Blower Motor Fuse Replacement

Bulletin Type:	Safety Recall	Publication Date:	April 2019
Bulletin #(s):	Jayco 19V-265 2019-166 Entegra 19V-270 2019-167	Make(s):	Jayco / Entegra
Job Code(s):	9903432	Model(s):	Precept / Alante Precept Prestige Vision / Emblem
Flat Rate(s):	.3 hour	Model Year(s):	2014-2019

FIG 3

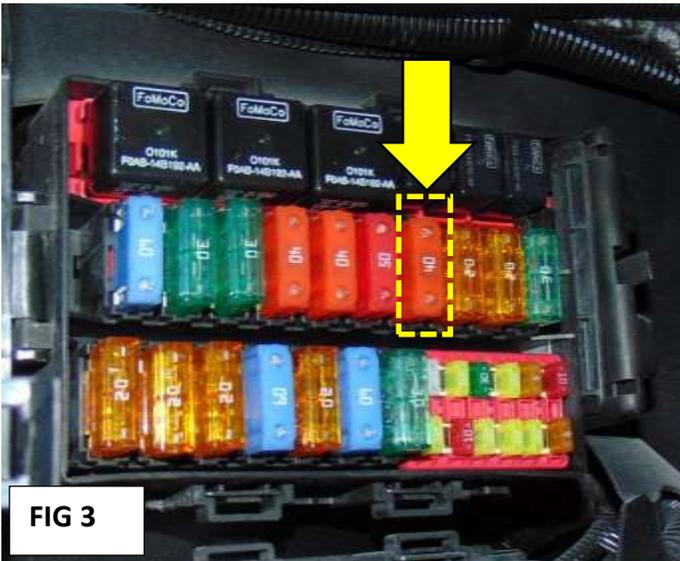
- 40 Amp red fuse. (4th fuse from the right side).
- This is fuse position #23 as indicated on the fuse box lid (arrow and dashed box in Figure 4).
- Remove the 40A fuse in position #23.
- Save the 40A fuse as a spare as there are other 40A fuses in the box.

FIG 4

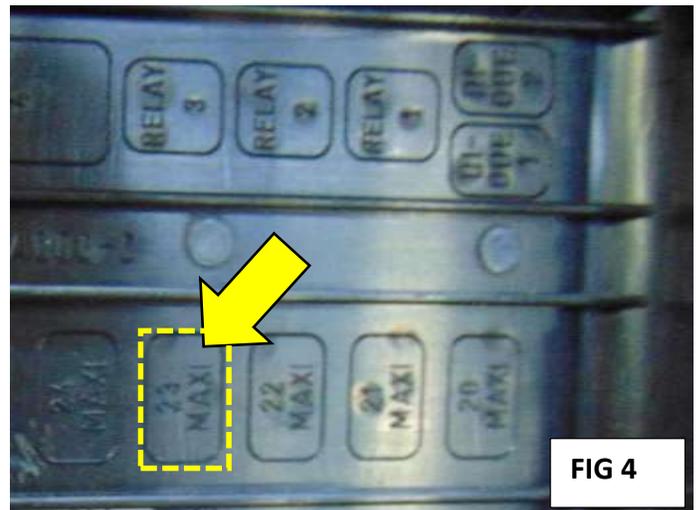
- Install the 25A Maxi fuse from the kit in place of the 40A fuse in position #23 in fuse box (arrow and dashed box).
